Tanker Q&As and CIs on the IACS CSR Knowledge Centre

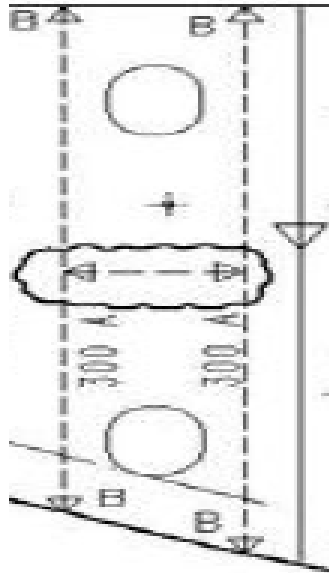
Requirement is given in Sec.2/3.1.8.2. Is normally based on cargo density from loading manual, however it is shown that increased density have no effect on fatigue life (dominated by ballast condition below NA) except from uppermost stiffeners in cargo tank, which will not be subject to pressure due to reduced filling.

KC#991

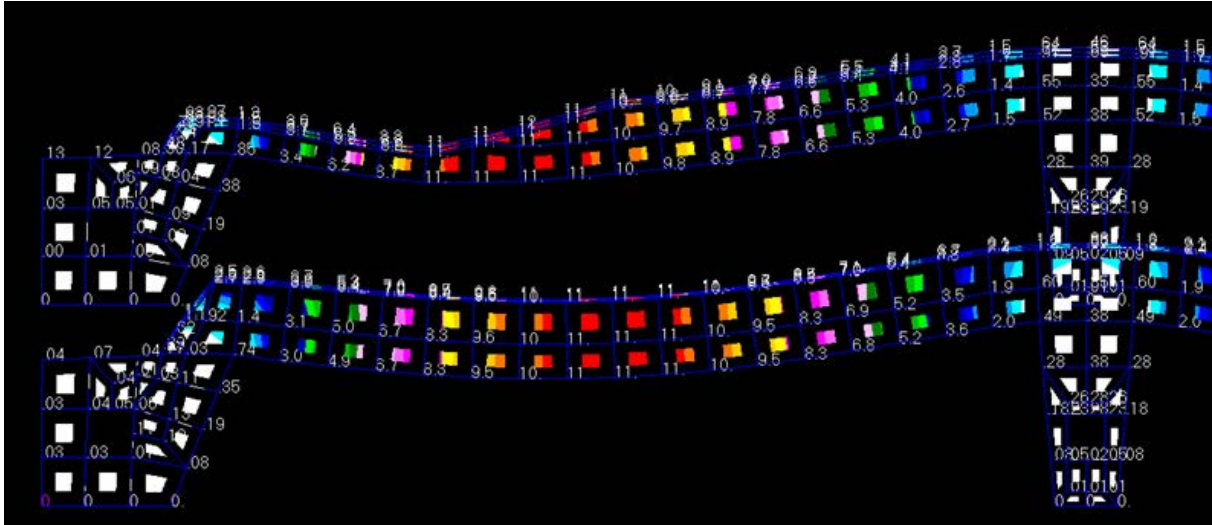
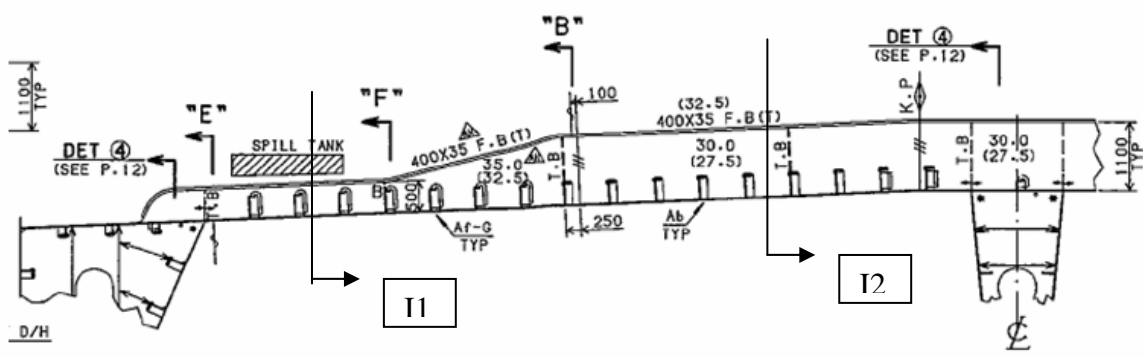
991 attc	8/2.6.4.1	CI	Web depth of deck transverses	2010/3/8	<p>The web depth of deck transverse is to be checked by 8/2.6.4.1 together with CIP-T5 for 3/5.3.3.4. In case the web depth is varying along the span due to interruption by manifold (See attached), mean inertia of moment along the span is to be used considering maximum deflection at mid span provided that the reduced web dept is not more than 50% of whole span. Based on FE analyses this approach found quite reasonable. Please clarify whether the mean inertia of moment ($(I1+I2 / 2)$) can be used for calculation of the required equivalent inertia of moment.</p>	<p>The procedure offered in CI-5 item 3 is considered sufficient for this purpose and the mean moment of inertia cannot be used to satisfy the Rule requirement.</p>	Y
992	8/2.6.4.4	CI	net shear area	2009/12/11	<p>In this paragraph the net shear area to be calculated based on both cargo pressure and green sea pressure. For green sea pressure, the requirement should be applicable only for 20% from the end of the whole span since there is no shear force from the side transverse or vertical web frame on the longitudinal bulkheads. There is no shear at the mid span of deck transverse. Please clarify whether shear requirement with green sea pressure should be applied to whole span of deck transverse.</p>	<p>The shear requirement with green sea pressure is to be applied to the whole span of deck transverse. Please also see the Technical Background document on the IACS website.</p>

KC#1079

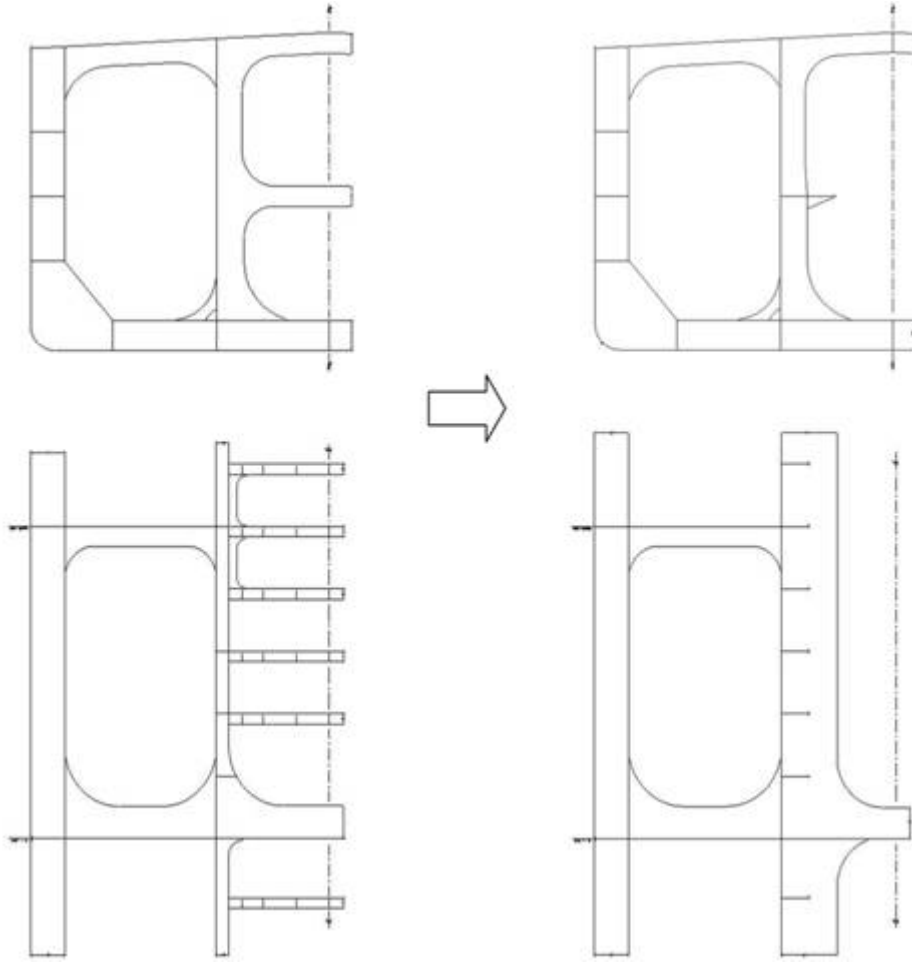
KCID No.	Ref.	Type	Topic	Date completed	Question/CI	Answer	Attachment
1079 attc	Tanker 8/2.6.6&7	Interpretation	Alternative primary supporting member arrangement for VLCC whose arrangement is not covered by current CSR.	2010/11/22	<p>Reference is made to alternative primary supporting member arrangement for VLCC whose arrangement is not covered by current CSR. We are considering deep horizontal longitudinal stringer on longitudinal bulkheads in lieu of cross tie which support vertical webs as shown in Fig.1. However, current CSR does not take into account the effect of stringer for the scantling of vertical web and does not offer applicable prescriptive rule for the stringer.</p> <p>In this regard, we would like to propose following procedure for the scantling of such alternative design:</p> <p>1.Vertical web The scantling will be determined according to current prescriptive rule without cross tie in center tank. However, in this case, the load to stringer obtained by Beam Theory will be applied to stringer as its design load at vertical web positions. And then, the design bending moment and shear force will be reduced considering the effect of stringer.</p> <p>2.Deep longitudinal stringer The scantling will be determined according to the requirement in 8/2.6.7 of the rule with M(bending moment) and Q(shear force) obtained by Beam Theory for design load as mentioned in 1.</p>	<p>Your proposed approach for scantling assessment is in general agreed with.</p> <p>Section 8/7 for general purpose strength requirements as indicated in 8/7.1.1.1 should be applied to the extent possible. Further we advise that the application of minimum thickness and slenderness ratio requirements in Section 8/2 to PSM should be made.</p> <p>Subsequent FE assessment should also be carried out, and critical locations should be evaluated in fine mesh FEA.</p>	Y

KC#1095

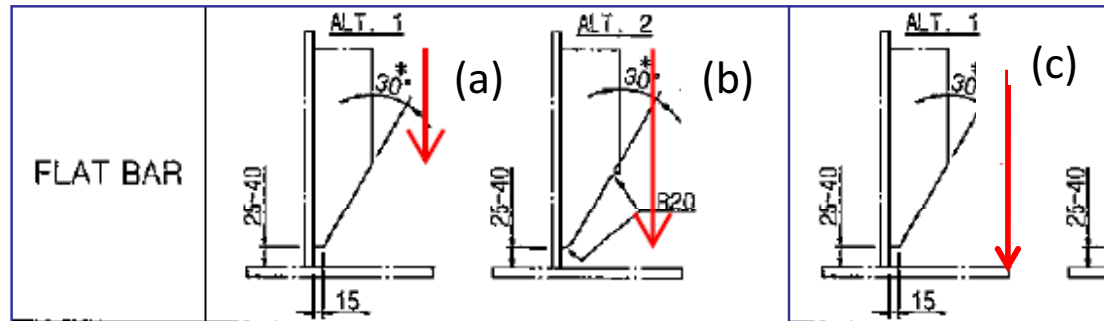
1095 attc	8/6.2.5.3	Interpretation	Definition of effective bending span l_bdg	2011/2/7	The definition of effective bending span l_bdg of Sec8/6.2.5.3 refers to Sec4/2.1 of the rules. In case of the web stiffener is sniped at the end, please confirm which length is to be used among (a), (b) and (c) from attached details.	The full length between supports i.e., (c) should be taken. See also Section 4/2.1.1.3.	Y
1099 attc	8/4.1.1.1	Interpretation	Application of the Common Interpretation CI-T8	2011/4/11	<p>With regards to the application of the Common Interpretation CI-T8, we have an interpretation request which is shown in attachment.</p> <p>Question:</p> <p>1. Regarding to this tapering requirement, should we use the required t_end at the E.P.P of the panel i.w.o. Machinery Space (Applicable Rule Sec. 8/4 "MACHINERY SPACE")?</p> <p>2.Or, should we use the required t_end at the E.P.P of the panel i.w.o. Aft End (Applicable Rule Sec. 8/5 "AFT END")?</p>	No.2 since intention of tapering is to have reasonable plate thickness transition from midship to aft peak bulkheads at aft end side (Not engine room side).	Y

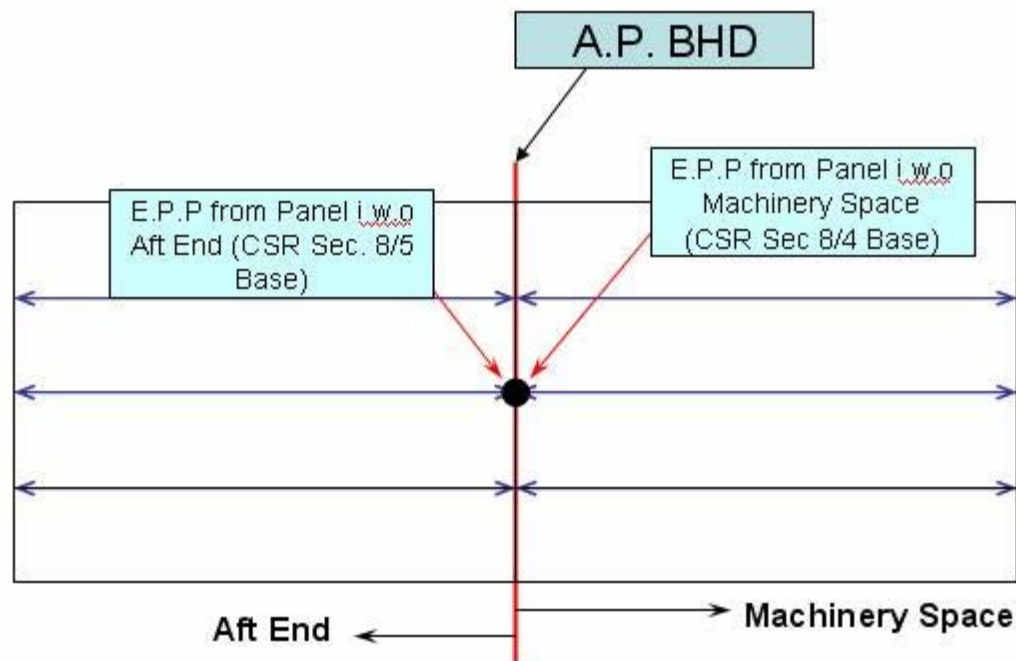
As shown on the above, t_{end} should be used the NET REQUIRED THICKNESS at A.P BHD in the tapering formula.

However, considering the actual structure, a debate are possibly made depending on the considering panels' net required thickness as shown below picture.

Question,

1. Regarding to this tapering requirement, should we use the required t_{end} at the E.P.P of the panel i.w.o. Machinery Space (Applicable Rule Sec. 8/4 "MACHINERY SPACE")?
2. or should we use the required t_{end} at the E.P.P of the panel i.w.o. Aft End (Applicable Rule Sec. 8/5 "AFT END")?
